Southampton to London Pipeline Project

Responses to ExA's Further Written Questions -
Queen Elizabeth Country Park (QE)

Application Document: 8.42

Southampton to London Pipeline Project
Response to the Examining Authority's Further Written Questions – Queen Elizabeth Country Park (QE)

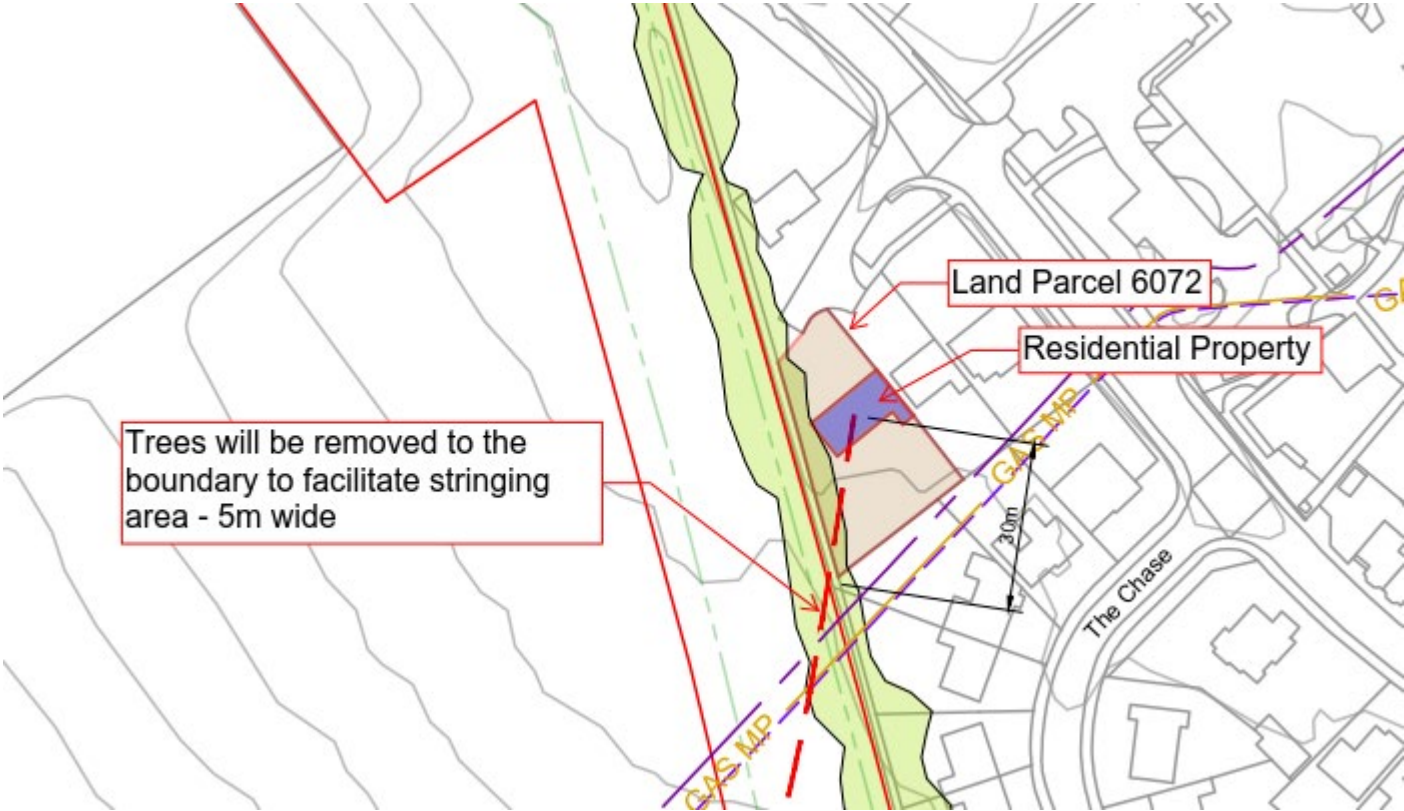
ExQ2	Question:	Applicant response to Question:
	<p>i) Justify the reason for not including the stringing out area adjacent to the 10m NWW, and the reasons for the proposed route as depicted in Figure 1.2 within [REP3-013].</p> <p>ii) Signpost in the Application where an assessment of the effects of the stringing out area has been undertaken and assessed.</p>	
<p>QE.2.2</p>	<p>At the ISH held on Tuesday 3 December 2019 [EV-009a and EV-009b], the Neighbours and Users of Queen</p>	<p>1.1 The Applicant can confirm that it is technically feasible to HDD beneath QEP, but doing so would, in the Applicant's view, transfer effects versus the Open Cut in QEP. As outlined in the detail covered below, considerations include:</p> <ul style="list-style-type: none"> • greater level of engineering risk and uncertainty; • larger land footprint;

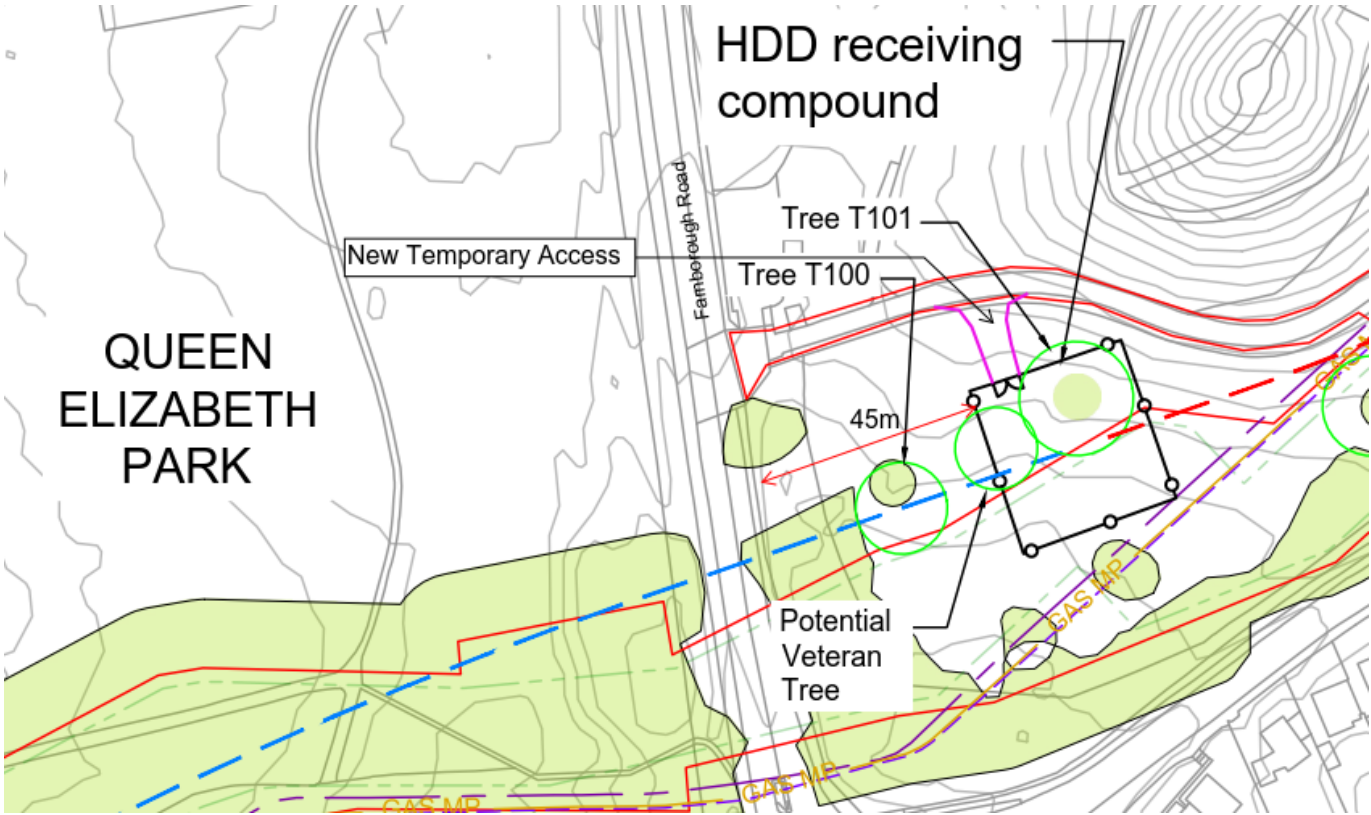
ExQ2	Question:	Applicant response to Question:
	<p>response [REP3-059], the response given by the Applicant appears to differ from a previous response given at 1.3 of the response to ExA WQ QE.1.5[PD-008] at D2 [REP2-048], in which it was cited that the trenchless techniques would have no greater benefit than open trenching.</p> <p>The sketches provided in the response to Action Point 15 would however seem to indicate it may be possible at least with option 1 utilising the maximum radius</p>	<p>Illustration 2: Enlarged image of HDD from play area in QEP to Farnborough School</p>  <p>1.4 The proposed stringing out of the pipe through the school outfield would not be able to follow the line of the Open Cut which hugs the school boundary. This is due to the maximum radius of curvature of</p>

ExQ2	Question:	Applicant response to Question:
	<p>of curvature of 400m that with some modification to the receptor pit location that the whole stringing out length required could be accommodated within the Farnborough School site or potentially utilising the end of Woodstocks off Ship Lane for the end of the stringing section.</p> <p>Provide a more detailed feasibility assessment of the potential for stringing out to be undertaken in Farnborough School.</p>	<p>400m that the string is able to achieve. The works to the Open Cut and the stringing would all have to take place at the same time, as the project has committed to undertake the works within the school grounds only outside of term times. This would result in two separate work fronts and a larger working footprint being needed. This would impact on the availability of the area for the school to undertake its out-of-term-time activities. As identified in Action Point 15 (REP3-013), HDD does introduce additional risk from engineering risk and uncertainty, which would make it harder to meet the commitment to only work in out-of-term-time.</p> <p>1.5 In response to the comment regarding realigning the reception pit, the Applicant has endeavoured to show the impact that a reception pit in this area would have on the local trees in the sketch below. There is limited open space in the southeast corner of the school grounds, and any reorientation has the potential to require further trees to be removed. In the area where the reception pit would be located, there are a number of complications and obstructions which the Applicant has to take account of: there are trees within the Conservation Area (two are recorded as veteran trees), the existing fuel lines and the school's access road. The assumed location is derived from the following limitations listed below:</p> <ul style="list-style-type: none"> • Addressing the trees in the first instance, Tree T101 would have to be removed, along with the veteran tree. Tree T100 should be able to be retained but may require some lopping or trimming. • The existing fuel lines can be avoided if the reception pit remains as shown on the sketch below. There is limited potential to expand this worksite due to the proximity of the existing lines without additional protection being installed. • A new access would need to be installed off the existing school entrance road to afford direct access into the reception pit area. • The location of the reception pit would dictate how long the stringing out length of the pipe needs to be. Therefore, the closer the reception pit could be located to the A325, the shorter the length of string in the school fields. However, the reception pit cannot be moved any closer to the A325

ExQ2	Question:	Applicant response to Question:
		<p>– 45m at present – due to the depth and the bending radius that the pipe needs to be for the pipe to be routed beneath the A325.</p>

ExQ2	Question:	Applicant response to Question:
		1.6 While a trenchless crossing of Queen Elizabeth Park is physically possible, the Applicant maintains that its adverse impacts would be greater than the current proposal for Open Cut.
QE.2.3	<p>Explain why there is need for such an enlarged drive site shown in response to Action Point 15 [REP3-013], when at Stakes Lane the drive site is contained within a much smaller footprint.</p>	1.1 HDD working areas are all based on a standard size, with the exception of Stakes Lane due to the limited footprint available between the residential properties and railway embankment, and it would require a bespoke set up for this location with restrictive methodologies being applied.
QE.2.6	<p>At the Accompanied Site Inspection held on Tuesday 26 November 2019 [EV-008], the ExA noted a raised brick structure near to the boundary with Farnborough Road with in what appeared to be</p>	<p>1.1 In response to (i), the Applicant can confirm that the brick structure is a Thames Water structure. Thames Water has confirmed that the structure houses an air valve located on its 525mm diameter pumped foul sewer rising main and is located at this location as it is a 'high' point in the system.</p> <p>1.2 In response to (ii), the Applicant can confirm that the pipeline alignment would be routed to the north of this structure, and the structure would have no bearing or impact on the Applicant's development.</p>
